**Study Team Response to Comments and Recommendations  
contained in the  
NWRI Independent Advisory Panel Final Report  
(dated January 12, 2018)**

The LOTT Clean Water Alliance (LOTT) is completing a scientific study of reclaimed water and groundwater recharge called the Reclaimed Water Infiltration Scientific Study (RWIS). LOTT has contracted with the National Water Research Institute (NWRI) to convene an expert panel to perform a scientific third-party peer review of the RWIS project. This panel held its second project meeting on November 17, 2017, at which the LOTT Study Team presented technical material and posed questions to the panel. The NWRI peer review panel issued a report dated January 12, 2018, titled “*Final Panel Report for Meeting #2 LOTT Clean Water Alliance Reclaimed Water Infiltration Study*”. The report presents the comments and recommendations from the peer review panel regarding the topics and documents discussed at Meeting #2.

Figure 1. Estimated concentration of bromide in groundwater downgradient from recharge basins assuming an inflow concentration of 25 mg/L.

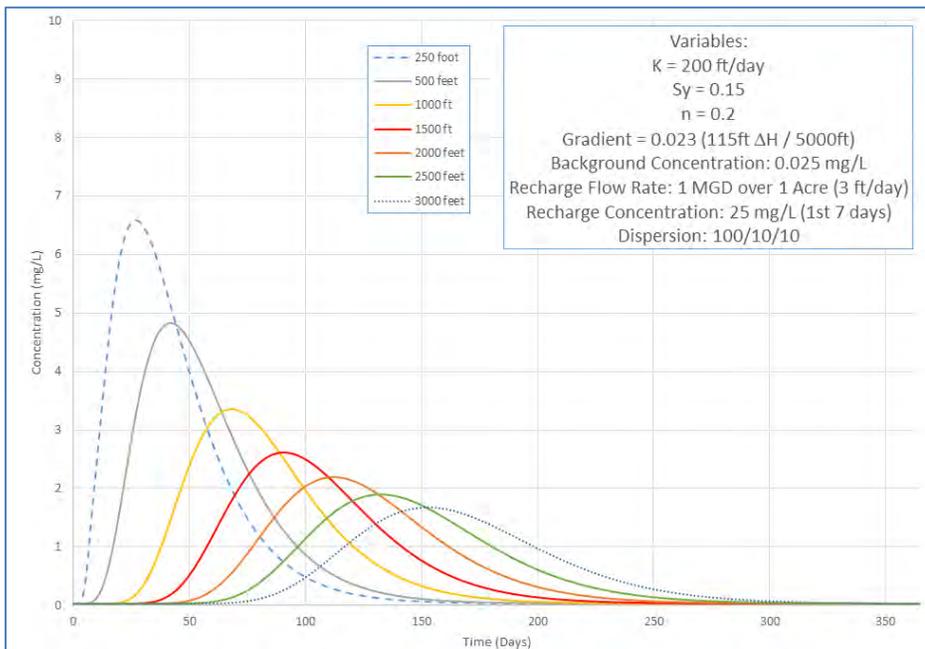
- It would be useful for LOTT and/or its project team to estimate (a) the bromide concentration expected at the closest drinking water well and (b) how long after the tracer addition that bromide concentrations may occur. It also would be important to know what water treatment processes are provided for the extracted drinking water. This information can help determine relative risk and if any actions are warranted to reduce risk, such as adding a process at the drinking water well if needed to remove bromide during the tracer study.

The estimated downgradient concentrations of bromide were provided in the draft work plan and were presented during the peer review meeting. Since then, two changes have been made and the work plan has been revised:

- The concentration of potassium bromide has been changed to 25 mg/L from the original concentration of 50 mg/L, based on discussion with the Science Task Force and in response to Peer Review input.

- The introduction of the potassium bromide has been changed to be upstream of Basin 4 and will be completely mixed prior to entering Basin 4.

There are no drinking water wells in the immediate vicinity of the project site that withdraw water from the same aquifer (Qva) into which the tracers are being introduced. Based on a review of well log records maintained by the State Department of Ecology, the nearest downgradient drinking water wells in the Qva that are in the expected flowpath of the tracers (i.e., to the southwest of the project site) are located south of Interstate-5, and are more than one mile south of the project site. At least one public supply drinking water system has drinking water wells in the Qva aquifer and is located approximately 1.5 miles to the west/northwest of the project site; however, these wells are anticipated to be upgradient (i.e., above the flow path) from the project site.

As described in the Work Plan, tracer breakthrough modeling was conducted under various hydrogeologic scenarios and considering an initial bromide concentration of 20 mg/L. As noted above, LOTT has decided to use an initial bromide concentration of 25 mg/L, as compared with the originally-considered 50 mg/L. The model results for two model runs were extrapolated to determine bromide concentrations given an initial concentration of 25 mg/L. The results from the run having the most conservative (i.e., highest) downgradient bromide concentration is shown below. This indicates that at a distance of 3,000 feet from Basin 4, the peak downgradient bromide concentration, in addition to the existing background concentration of 0.01-0.04 mg/L, is expected to be 1 to 2 mg/L at a time of 150 days after tracer introduction. Further downgradient (down the flow path) beyond 3,000 feet, the groundwater gradient flattens considerably and bromide concentrations are anticipated to decrease significantly.
